Platform A1 - Booth area
Previous comments are
still valid, see following
slides

Platform A1 - Booth area

Important: the 12 columns of the Spray Booth have been modified after change of the Scrubber technology by Renault-VAZ

Axes 8/012

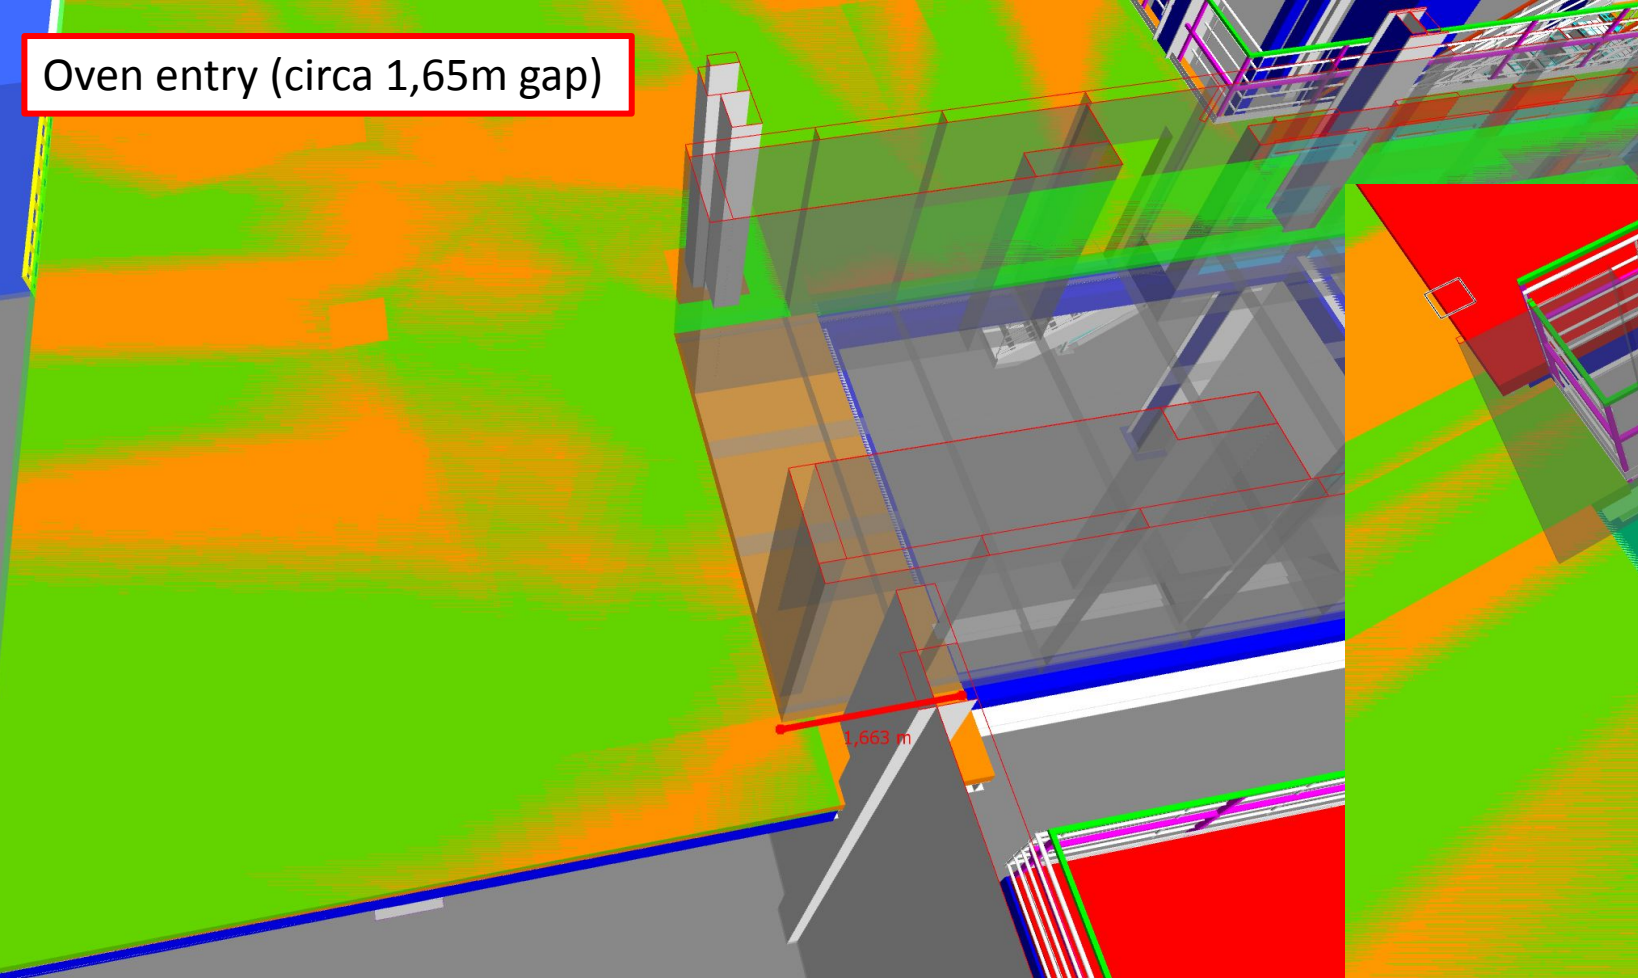
Oven entry (circa 1,65m gap)

Oven exit (circa 730mm gap)

Platform A1 – Oven area

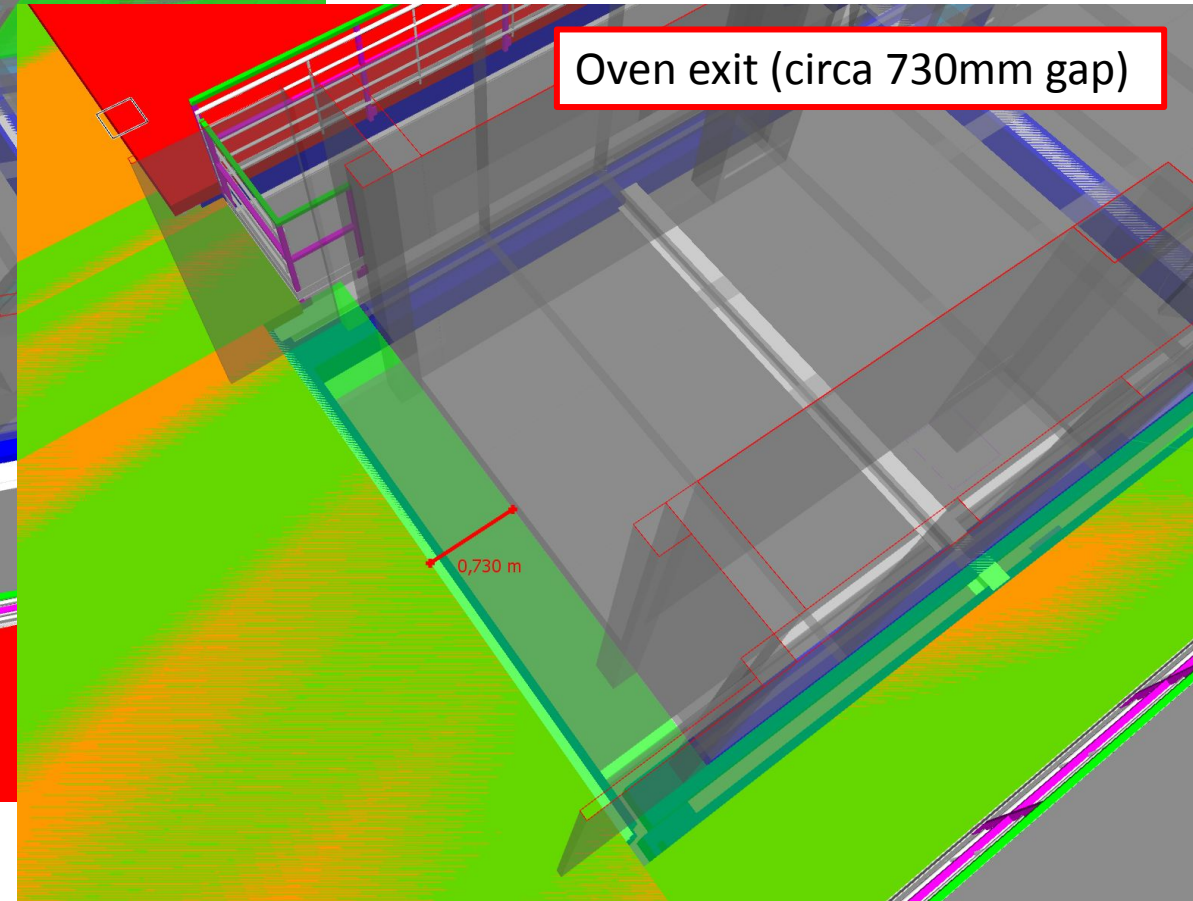
Oven center axis is positioned 3m west of axis 8

Update (08/06): the Oven load is only transferred to the two longitudinal beams on each side, there's no need to put more beams in the middle;
Also, the beams have to be no more than 145mm.

Axes 7-8/012-019

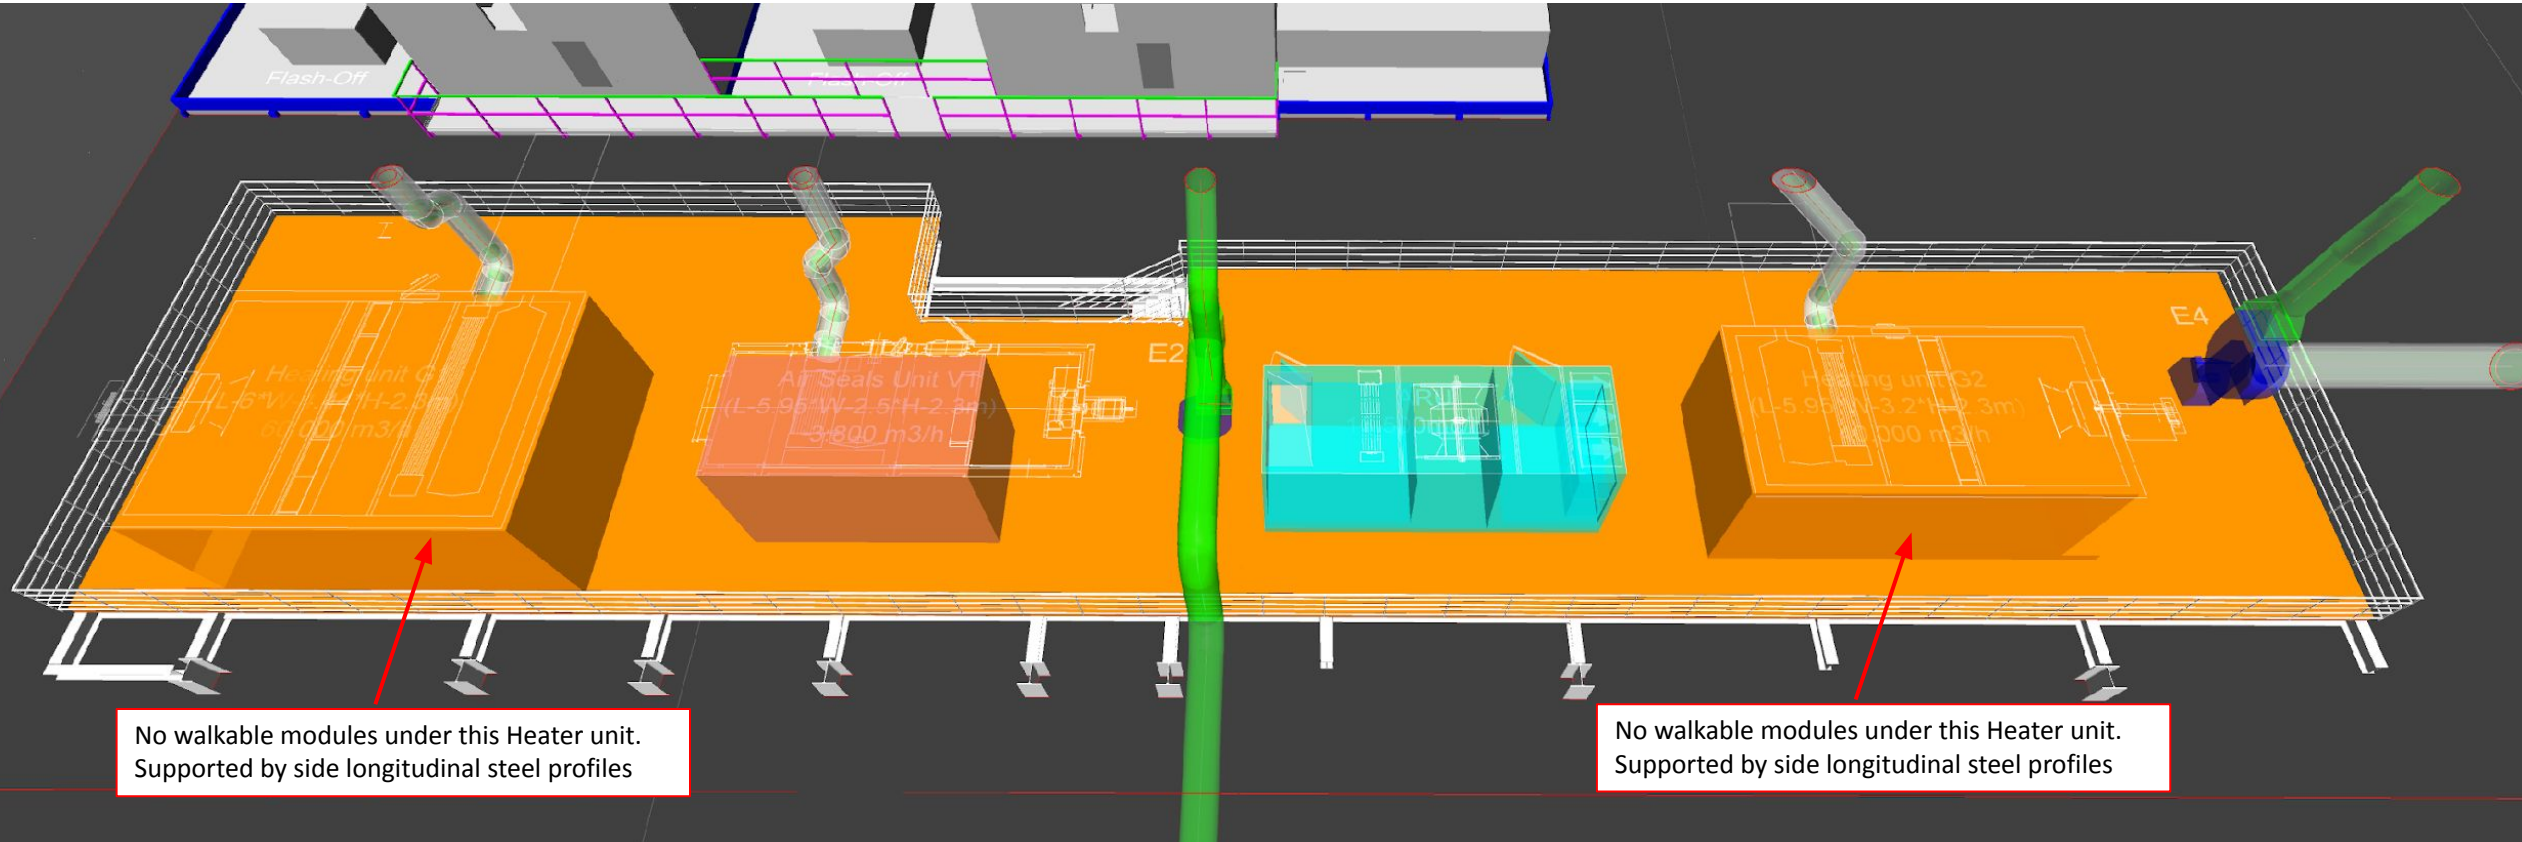
Keep in mind that we have ducts penetrating platforms under the two Heater groups, these ducts will have insulation (150mm all around).
I will submit information about these duct location in order to avoid clash with supporting beams

Platform A2 – Demasking & IRC area (axes 8-10/013-015):

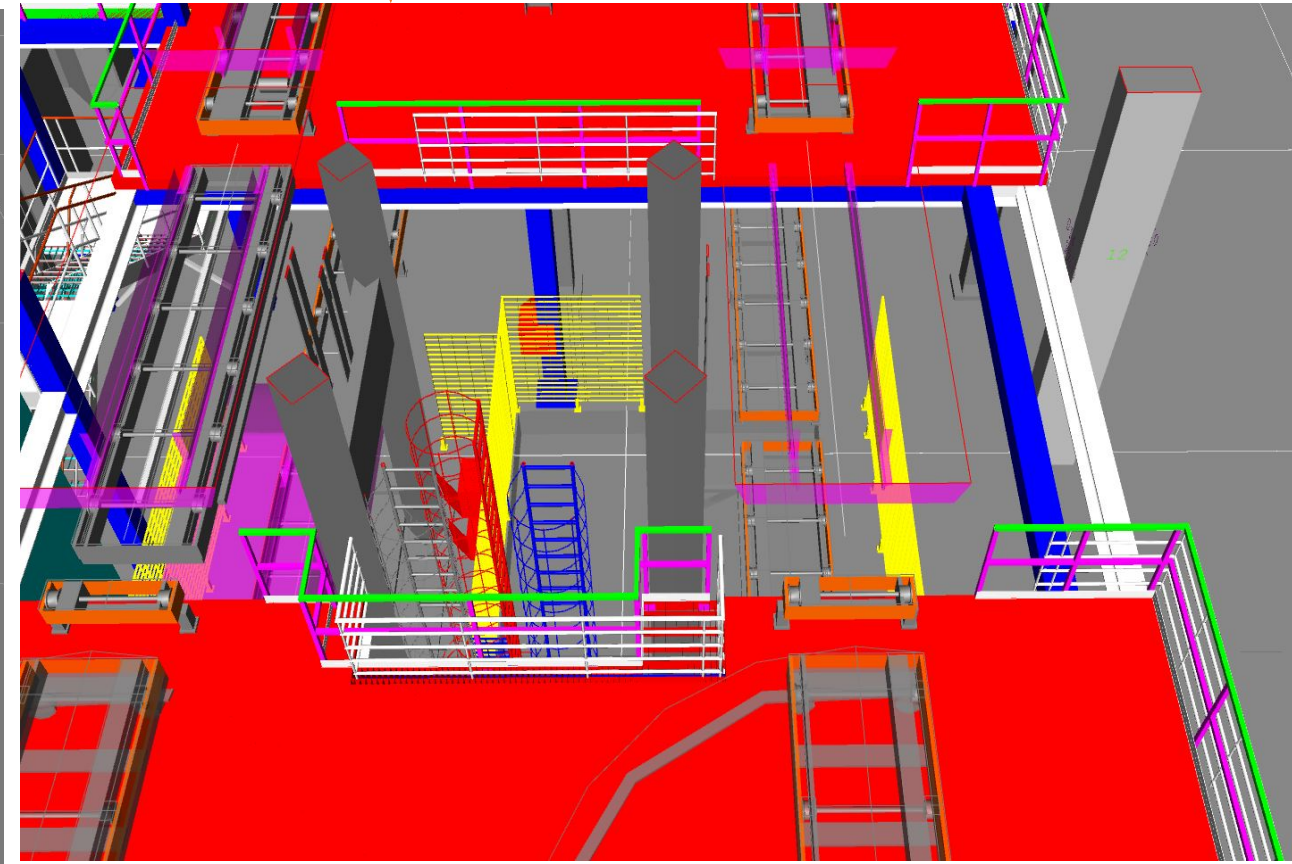
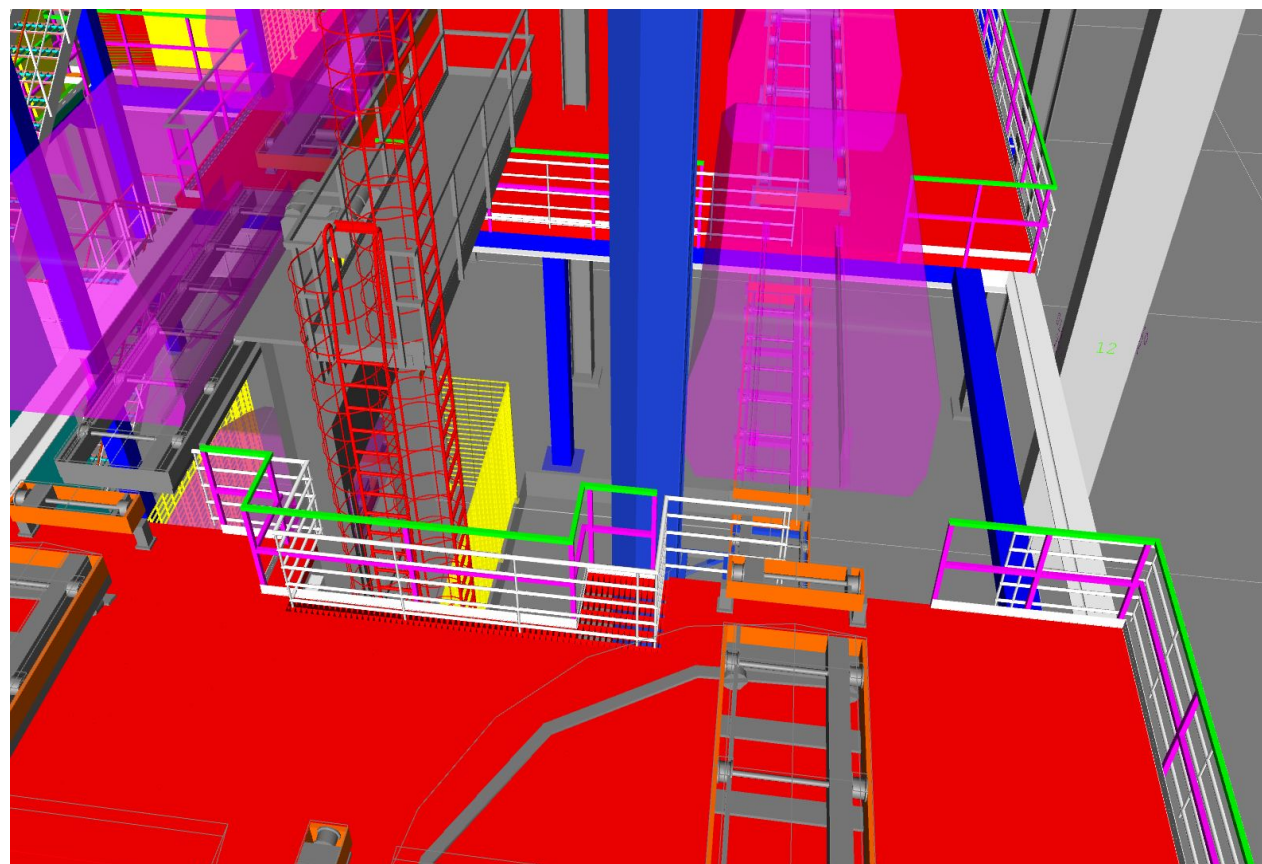
The area to be covered with walkable modules shall be the one circled in Yellow, basically under the two open Booths and under Electrical cabinets, as shown on General Layout uploaded in drive on 04 April (rev E – in progress)

Update:
Comment still valid

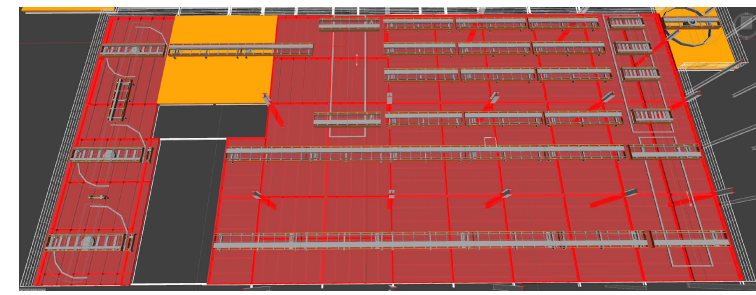
Platform A2: finally we need to discuss about longitudinal support for Conveyor
Roller-beds, turning tables and transfer-tables
I will send this information after I have discussed with my colleague from Conveyor dpt
Axes 10-12/014-020

As I told you last time I need to
give you precise info of where
to support the conveyor tables
(roller-beds, transfer table,
turning table)
In the meantime consider the
ones in these pictures (for
conveyor center-lines use the
Gen. Layout)
